CLARIFICATION # 7

Name of Project: Renewable Energy and Improved Utility Performance Project

Contract Title: Request for Bidding - Procurement of Plant, Design, Supply, and Installation for Five (5) Energy Storage Systems in FOGO Island, SANTO ANTÃO Island, SÃO NICOLAU Island, MAIO Island and BRAVA Island Cabo Verde

RFB Reference No.: 016/REIUP/UGPE_2

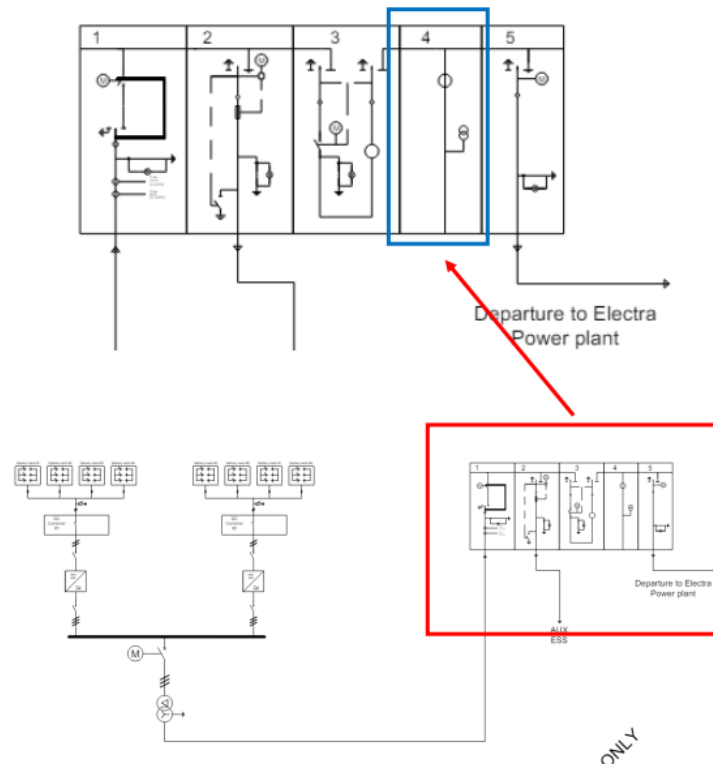
QUESTION 46: Question about the metering point for the capacity of BESS

As "appendix2-Battery Energy Storage System" shows, the guaranteed capacity should be measured at the scope of work battery limit. Would mind confirm for us that the fourth MV cabinet circled by blue box is the estimated metering point? In that case, we need to consider about the depth of discharge of battery and all components' efficiency when we design the system.

ANSWER N°46: Please refer to the Employer's requirements. The Contractor shall account for losses in the PCS and the step-up transformer components and auxiliary loads in rating the BESS discharge power and energy capacity. Note that drawings are given only for information..

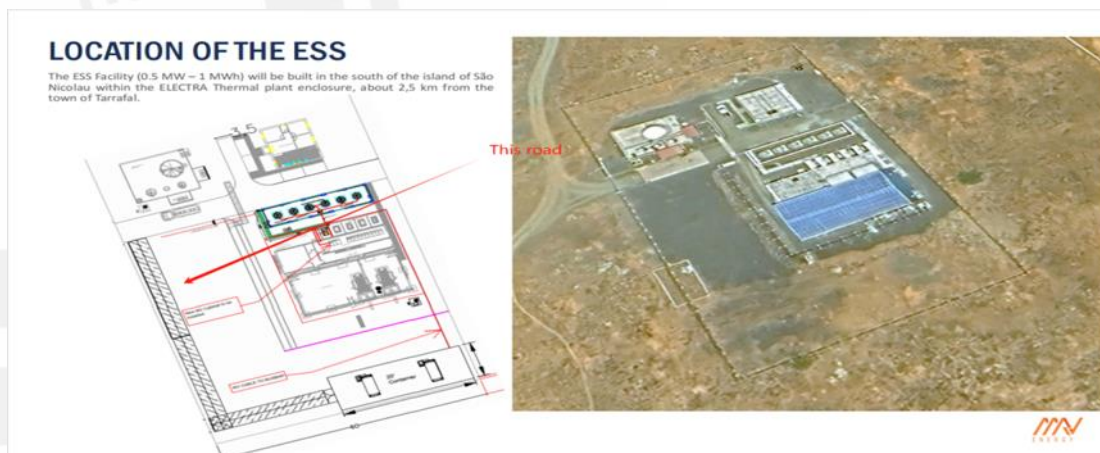
QUESTION 51: *Is the road in San NICOLAU Island, shown here, within the contractor's range?*

ANSWER N°51: Yes, it is.
